You need to add the following Parts to the manual ECUs*
to make the additional PWM Output (Low Side Driver) on Pin B24 work:

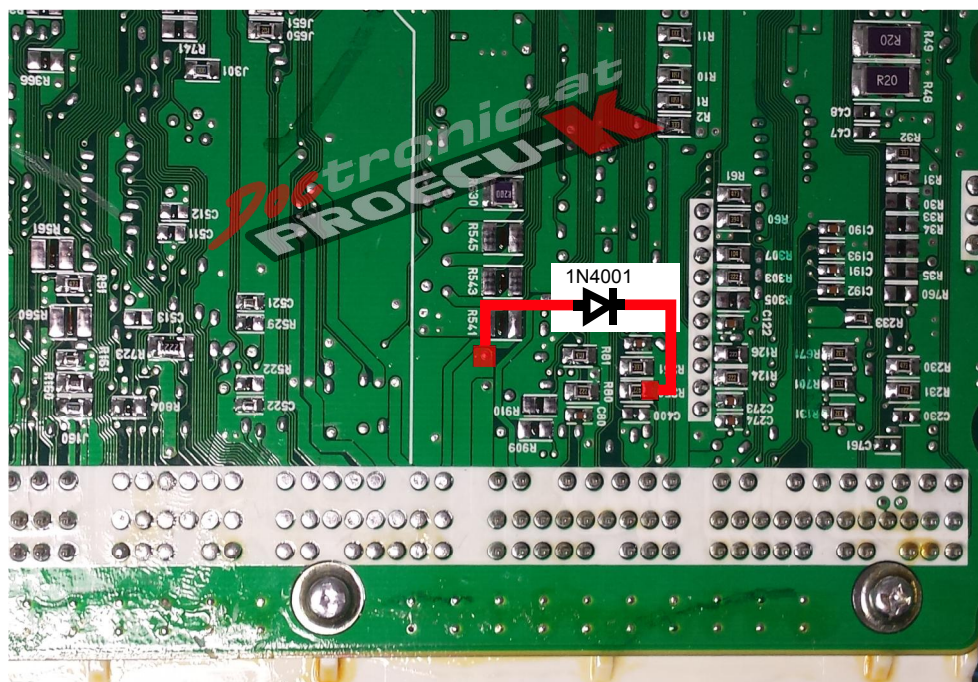
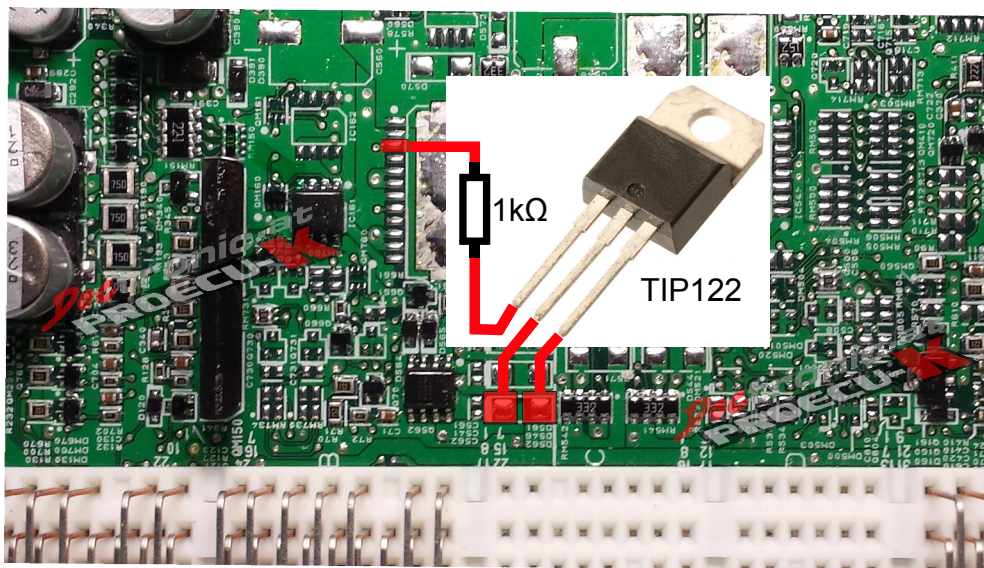
TIP122 (NPN Power Transistor)

1kOhm Resistor

1N4001 Diode

* (on automatic ECUs there is already a High Side Driver installed)
